UNITED STATES PATENT AND TRADEMARK OFFICE

| APPLICATION NO. | FILING DATE | FIRST NAMED INVENTOR | ATTORNEY DOCKET NO. | CONFIRMATION NO. |
|--|-------------|-----------------------|---------------------|------------------|
| 10/519,906 | 02/04/2005 | Alexandre Cury Schmid | 04304/0202236-USO | 2918 |

| Office Action Summary | Application No. | Applicant(s) |

DETAILED ACTION***Claim Rejections - 35 USC § 102***

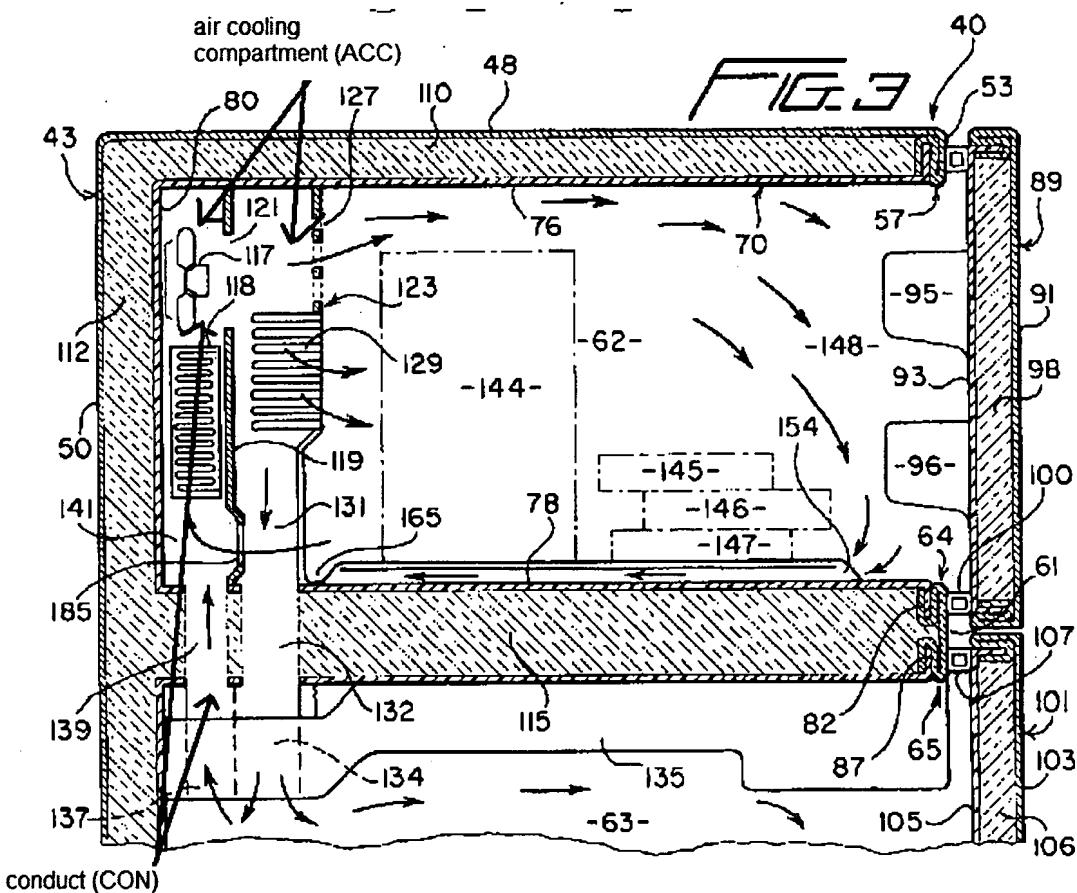
In regard to claim 1, Mandel et. al. teach an air distribution system (col 3 lines 26-28) for combined refrigerators (40) of the types which comprises a freezing compartment (62) (col 3 lines 66-67 and see Fig. 3) and a refrigerating compartment (63) (col 4 lines 3-4 and see Fig. 3), an air-cooling compartment (ACC, see annotated Fig. 3 below) lodging at least one evaporator (118) (see Fig. 3 and col 4 lines 22-23), a distributing duct (131) having a rear window (127) (col 4 lines 42-44) opened to the air-cooling compartment ((ACC, see annotated Fig. 3 below), at least one front opening (89) communicating with the freezing compartment (62) (col 3 lines 64-67). The front opening (89) allows a user to enter the freezing compartment (62) for maintenance or regular usage and the term "communicating" is interpreted to mean that the front opening (89) entrance leads to the location of the cool air contained in the freezing compartment (62).

Mandel et. al. also teach one end (139) opening maintained in communication with the refrigerating compartment (63) (see Fig. 3), and at least one fan (117) producing a forced airflow from the air-cooling compartment (ACC, see annotated Fig. 3 below) to the freezing compartment (62) and to the refrigerating compartment (63) (see Fig. 3 and col 4 lines 23-26), characterized in that the distributing duct (131) carries a conduct (CON, see annotated Fig. 3 below) having a first end (side further from fan 117) coupled to the end opening of the distributing duct (131) (see Fig. 3) and a second end (side closest to fan 117) selectively placed in fluid communication with one of the parts (121) defined by the distributing duct (131) and by the air-cooling compartment (ACC, see annotated Fig. 3 below) (col 4 lines 29-34 and see Fig. 3), said conduct being internal to the distributing duct (131) (see Fig. 3).

In regard to claim 2, Mandel et. al. teach the air distribution system characterized in that the conduct (CON, see annotated Fig. 3 below) is incorporated to the distributing duct (131) (see Fig. 3). It is interpreted that the term "incorporated" means the distributing duct (131) and conduct (CON) are placed side by side in the same air-cooling compartment (ACC).

In regard to claim 3, Mandel et. al. teach the air distribution system characterized in that the distributing duct (131) comprises a rear basic portion (78) (see Fig. 2 and col 5 lines 36-39) in the form of a vertically

disposed tray (154) having a rear wall (50) provided with a rear window (185) (see Fig. 3 and col 5 lines 55-56) and defining at least part of a front wall (61) of the air-cooling compartment (ACC, see annotated Fig. 3 below) and a front cover portion (64, 65) to be seated and affixed against the rear basic portion (78) and being provided with at least one front opening (101) (see Fig. 3 and col 3 lines 42-44).

In regard to claim 4, Mandel et. al. teach the air distribution system characterized in that the front cover portion (89) defines a wall portion of the conduct (CON, see annotated Fig. 3 below) when assembled (see Fig. 3).

In regard to claim 5, Mandel et. al. teach the air distribution system characterized in that the conduct (CON, see annotated Fig. 3 below) is maintained in selective fluid communication with one of the parts (118) defined by the distributing duct (131) and by the air-cooling compartment (ACC, see annotated Fig. 3 below) by means of respective front opening (89, 101) and rear opening (134) produced by the rupture of corresponding wall portions of the conduct (CON) (see annotated Fig. 3 below).

In regard to claim 6, Mandel et. al. teach the air distribution system characterized in that the conduct (CON, see annotated Fig. 3 below) conducts a forced airflow supplied through the inlet (132) opening coming from the distributing duct (131) to whose rear window (127) is operatively associated a fan (117) (see Fig. 3 and col 4 lines 54-56).

In regard to claim 7, Mandel et. al. teach the air distribution system characterized in that the conduct (CON, see annotated Fig. 3 below) conducts a forced airflow which is produced by a fan (117) that is operatively associated to the end opening (132) and to the refrigerating compartment (63) and which is supplied by the air-cooling compartment (ACC, see annotated Fig. 3 below) to the conduct through the rear opening (134) (see Fig. 3).
